THE MARYLAND-NATIONAL CAPITAL PARK AND PLANNING COMMISSION

**MEMORANDUM**

SUBJECT: MD 97/Randolph Road  
Intersection Improvement Study Recommendation  
(Project MO854B11)

**RECOMMENDATION: Transmit the following comments to the Maryland State Highway Administration:**

Exhibit 2

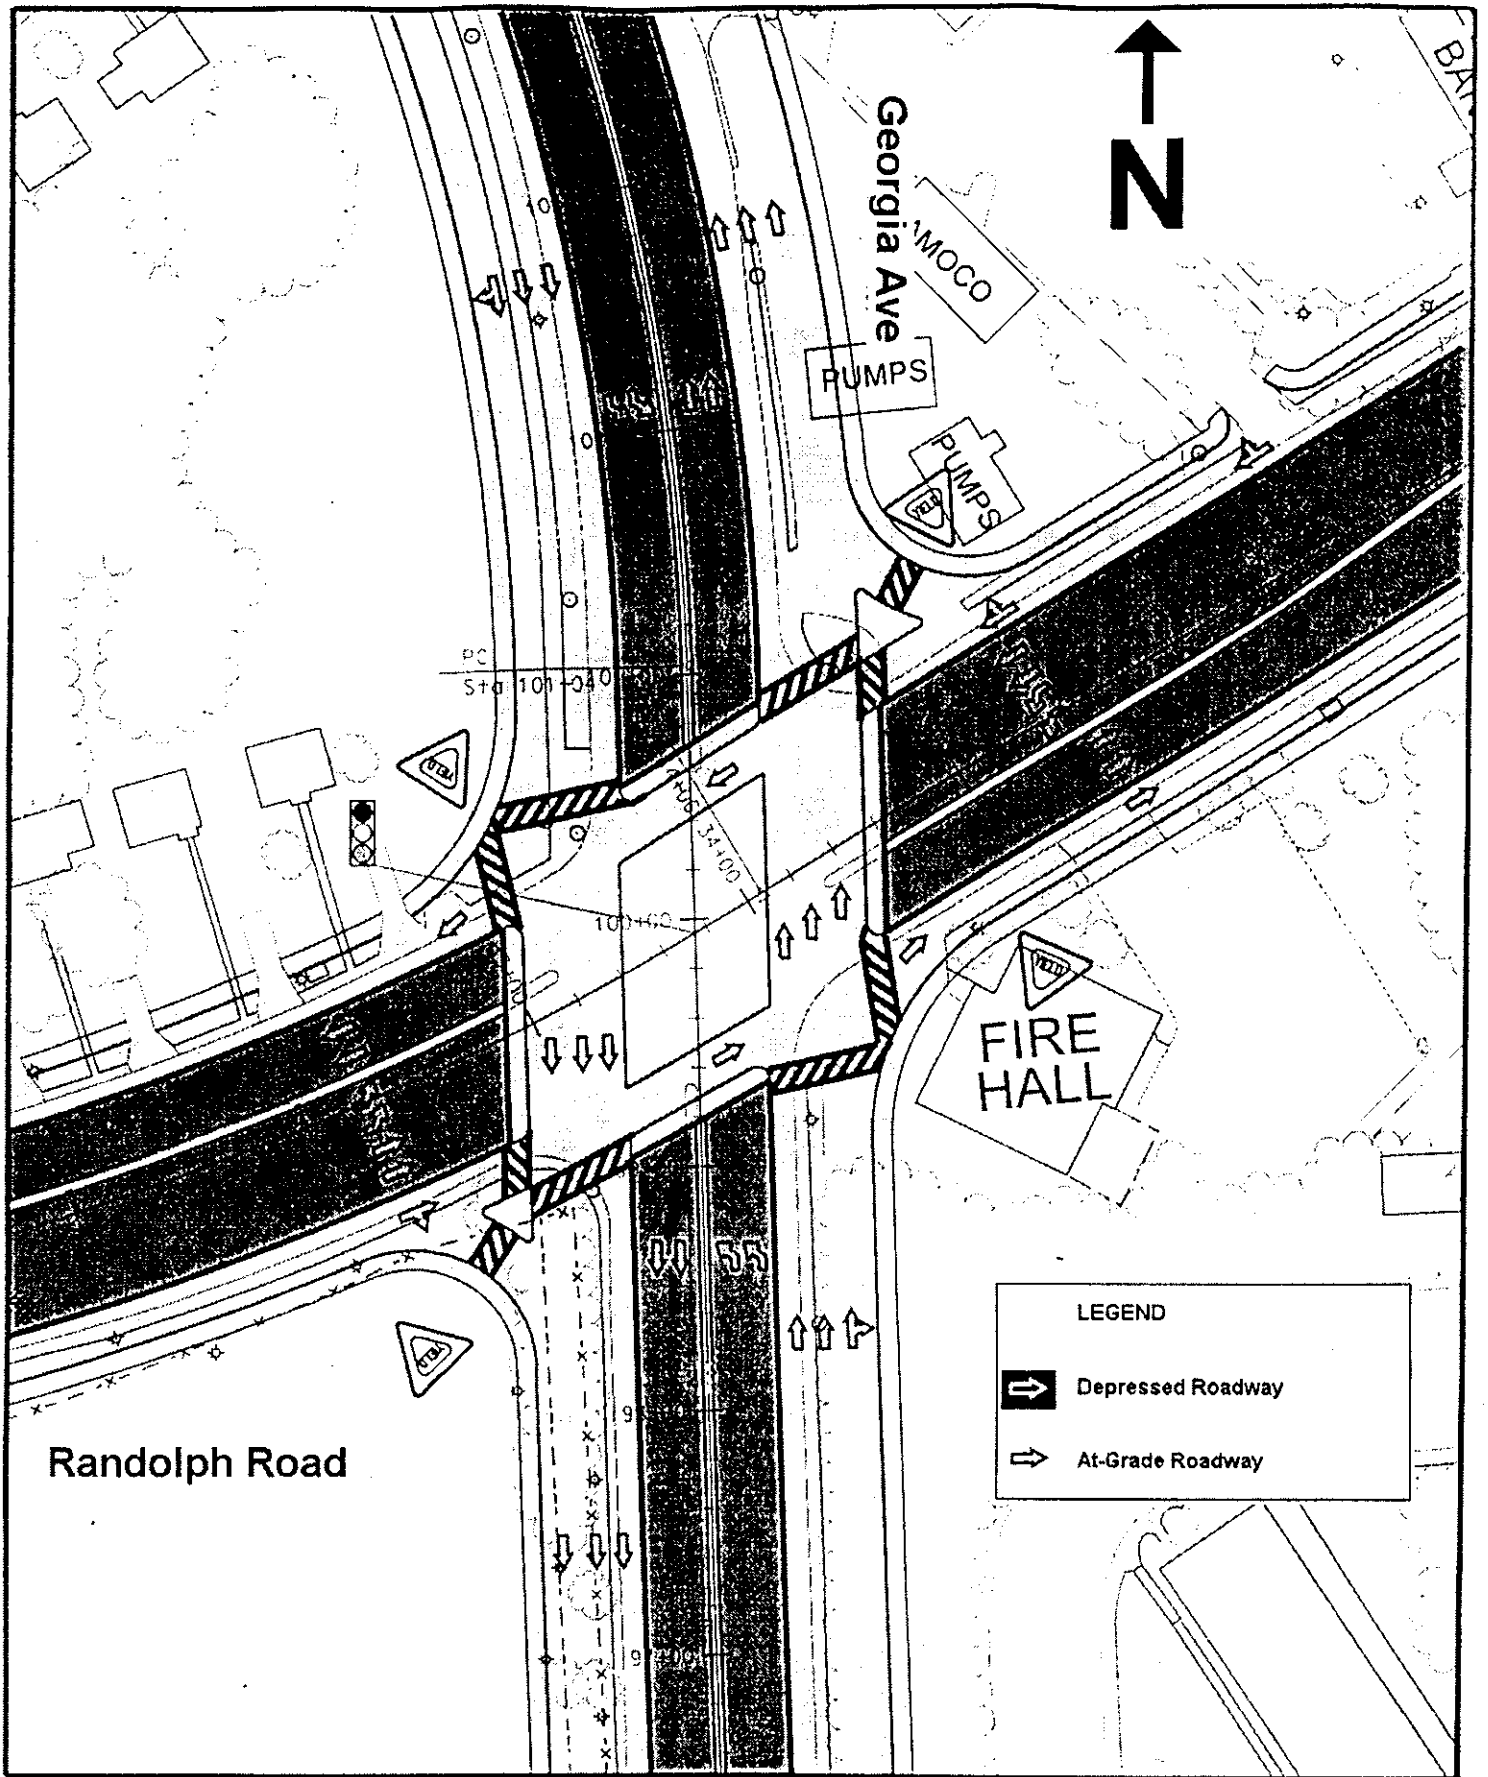
The primary drawback to choosing Alternate "C" over Alternate "B" is that, as currently designed, Alternate "B" provides a better pedestrian crossing of both Georgia Avenue and Randolph Road. Exhibits 2 and 3 provide close-up views of the at-grade portion of the Georgia Avenue/Randolph Road intersection for Alternate "B" and Alternate "C", respectively. Comparison of Exhibits 2 and 3 demonstrates that Alternate "B" provides shorter crosswalk lengths and wider median refuges than Alternate "C".

Exhibit 3

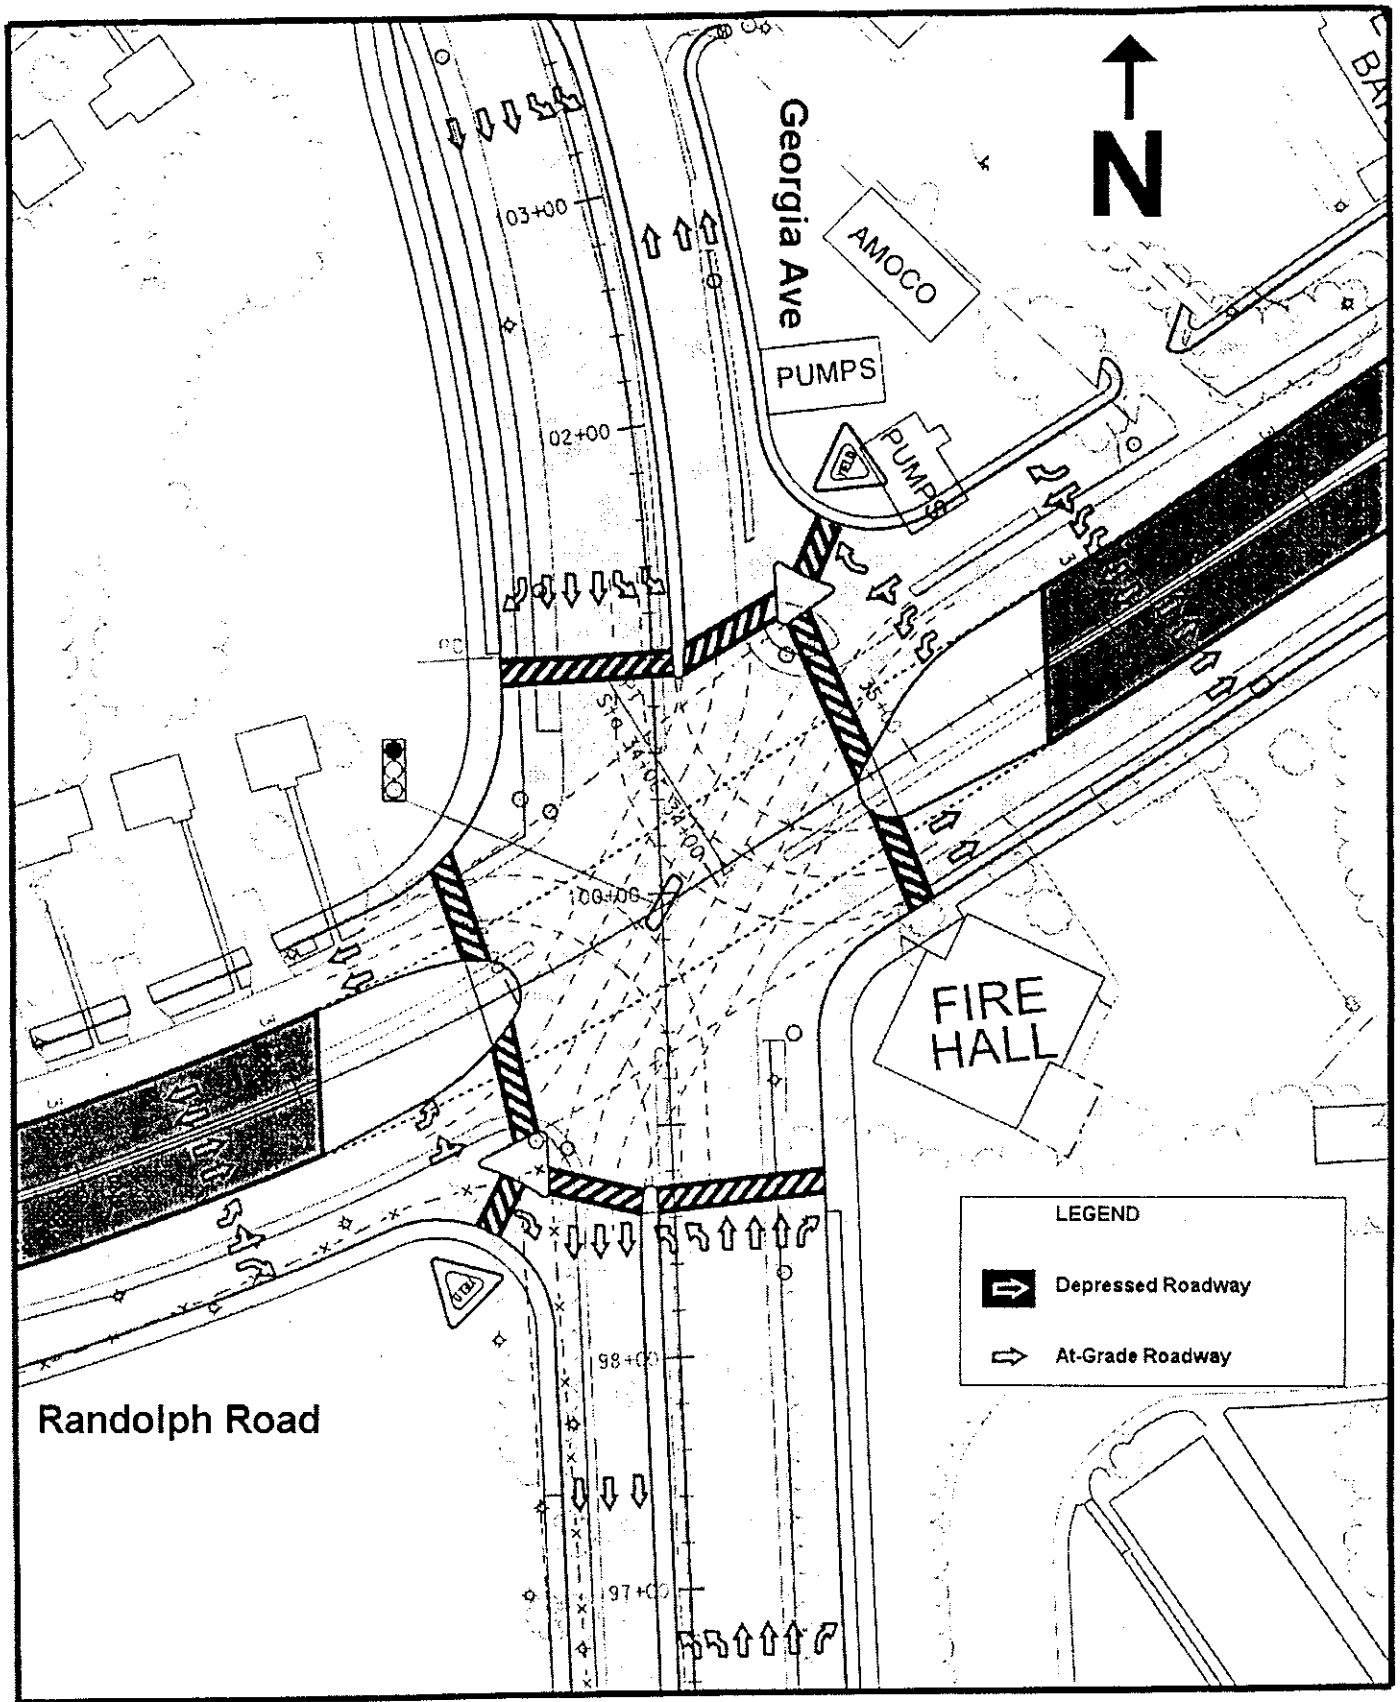
Georgia Avenue and Randolph Road meet at a slightly skewed angle, resulting in acute angle right turns in the northeast and southwest quadrants. As indicated in Exhibit 3, Alternate "C" channelizes these right turns, resulting in a "pork chop" island. (This characteristic, incidentally, also applies to Alternate "B".) The pedestrian connection between the island and the adjacent curb requires pedestrians to cross traffic that is controlled only by a yield sign. The curb radius in these quadrants will allow traffic to move at speeds higher than desirable from a pedestrian perspective. Staff recommends that three approaches be reviewed during detailed design -- removal of the "pork chop" island, reconfiguration of the channelization to promote slower travel speeds, or signalization of the right-turn movement.

Operational analysis of the pedestrian signal phasing is required to determine the adequacy of the eight-foot median width on Georgia Avenue. Because Alternate "C" employs "split" phasing for Randolph Road, pedestrians will likely be required to cross Georgia Avenue in two separate signal phases. The median refuge area must be designed to safely and comfortably accommodate future pedestrian volumes.
